ALCOA TECHNICAL

BULLETIN

April 2, 1998

Mounting/demounting tires on Alcoa 22.5 Non-Symmetrical Wide Base Wheels

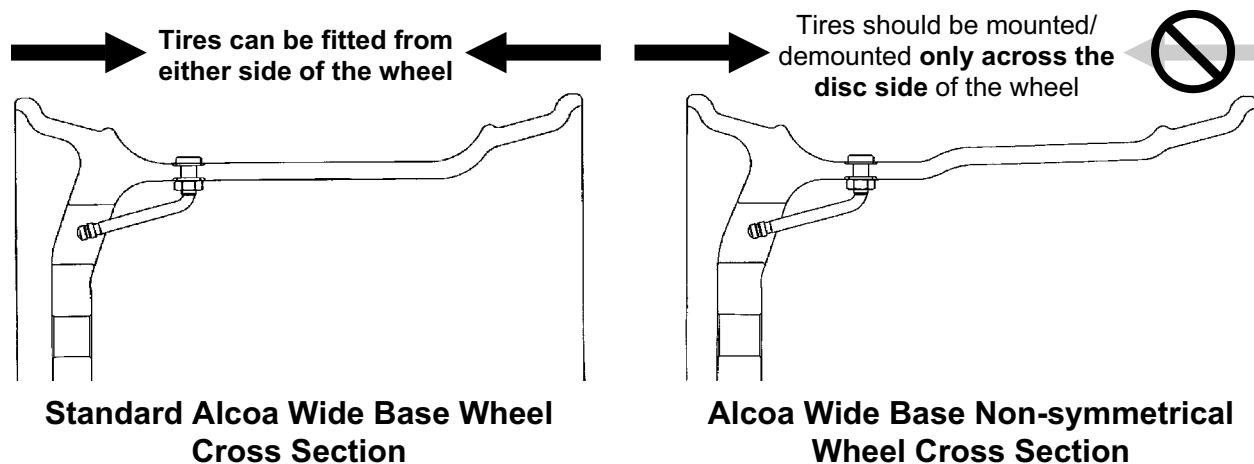
Alcoa has recently released a series of 22.5 forged aluminum Non-Symmetrical Wide Base wheels. These wheels feature a stepped wheel well which provides additional brake drum clearance. In order to minimize the possibility of bead damage, tires should be fitted and removed from the **disc side of wheel only**.

The part numbers will remain the same with an "A" suffix added and are interchangeable with existing wheel part numbers without the "A" suffix.
